Mike and Kathy Robitaille

53 Lovers Lane Ancaster Ontario (since April of 1984)

In order to regulate a zoning plan for The Town of Ancaster there first needs to be a starting point which should be the existing streetscape around any proposed new development, renovation or home addition.

Figure 12: Corner Lot Fabric – Scenario B

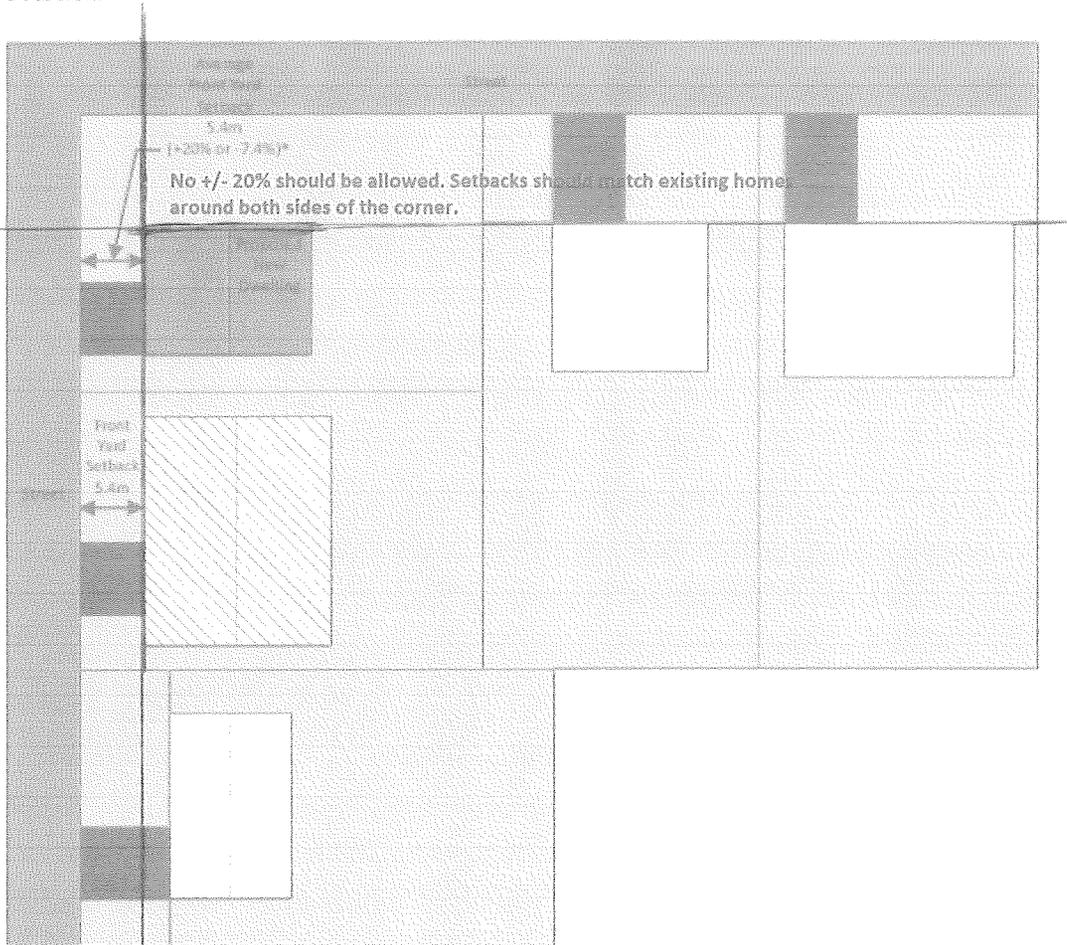
**In order to truly maintain the existing streetscapes of Ancaster the setback of any proposed new development or addition must match the setbacks of both adjacent, abutting, neighboring lots around both sides of the corner under review.**
